Golder Associates Inc.

July 21, 2003

RE: UNITED STATES SUGAR CORPORATION (U.S. SUGAR) – CLEWISTON MILL
PROPOSED NEW BOILER NO. 8
DEP PROJECT NO. 0510003-021-AC (PSD-FL-333)
ADDITIONAL INFORMATION RESPONSE #3

Figure C-6. Manufacturing and Agriculture Trends in Hendry County

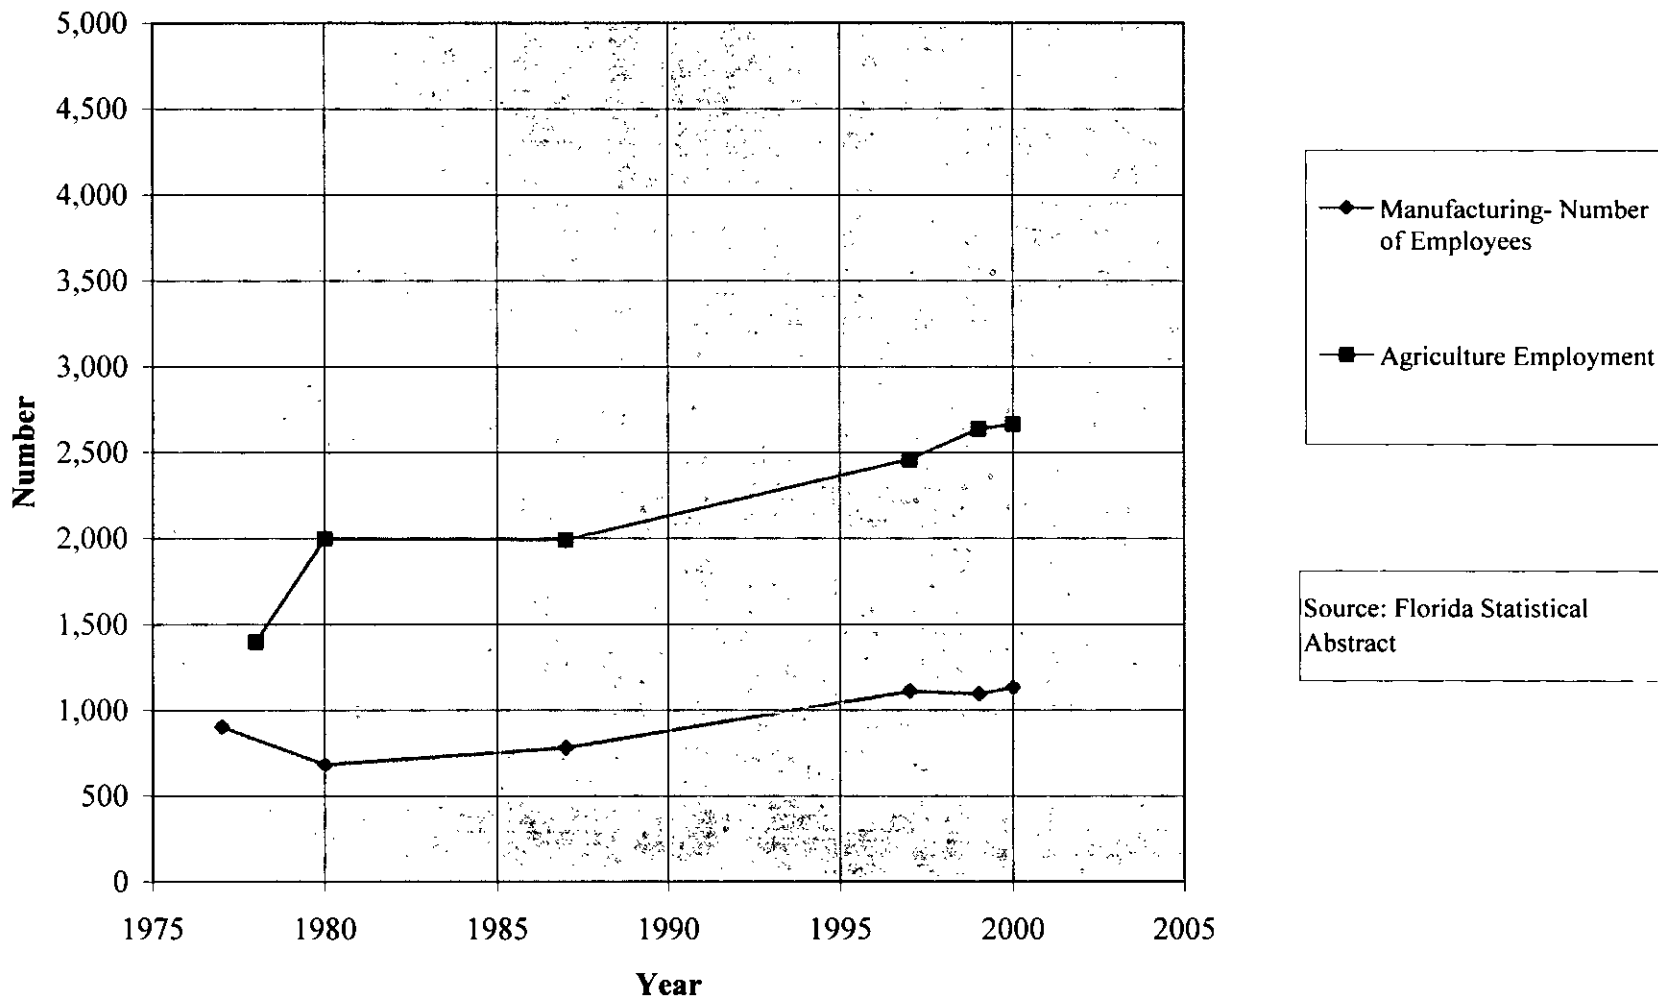
2. Rule 62-212.400(5)(h) 5, F.A.C. requires the applicant to provide information relating to the air quality impact of, and the nature and extent of, all general commercial, residential, industrial and other growth which has occurred since August 7, 1977, in the area the facility or modification would affect. Please provide this information. The additional impacts section 7.0 does not adequately address this requirement.

As an indicator of residential growth, the trend in the population and number of household units in Hendry County since 1977 are shown in Figure C-1. The county experienced a 114 percent increase in population for the years 1977 through 2000. During this period, there was an increase in population of about 19,300. Similarly, the number of households in the county increased by about 4,700 or 77 percent since 1977.

As an indicator of commercial growth in Hendry County, the trends in the number of commercial facilities and employees involved in retail and wholesale trade are presented in Figure C-2. The retail trade sector comprises establishments engaged in retailing merchandise. The retailing process is the final step in the distribution of merchandise. Retailers are, therefore, organized to sell merchandise in small quantities to the general public. The wholesale trade sector comprises establishments engaged in wholesaling merchandise. This sector includes merchant wholesalers who buy and own the goods they sell; manufacturers' sales branches and offices that sell products manufactured domestically by their own company; and agents and brokers who collect a commission or fee for arranging the sale of merchandise owned by others.

The trend in the labor force in Hendry County since 1977 is shown in Figure C-3. The greatest number of persons employed in Hendry County has been in the agriculture, services and government sectors. Between 1977 and 1999, approximately 6,265 persons were added to the available work force, for an increase of 87 percent.

Another indicator of commercial growth in Hendry County is the tourism industry. As an indicator of tourism growth in the county, the trend in the number of hotels and motels and the number of units at the hotels and motels are presented in Figure C-4.

As an indicator of transportation growth, the trend in the number of vehicle miles traveled (VMT) by motor vehicles on major roadways in Hendry County is presented in Figure C-5.

As an indicator of industrial growth, the trend in the number of employees in the manufacturing industry in Hendry County since 1977 is shown in Figure C-6. As shown, the manufacturing industry experienced a moderate increase of 25 percent from 1977 through 1997.
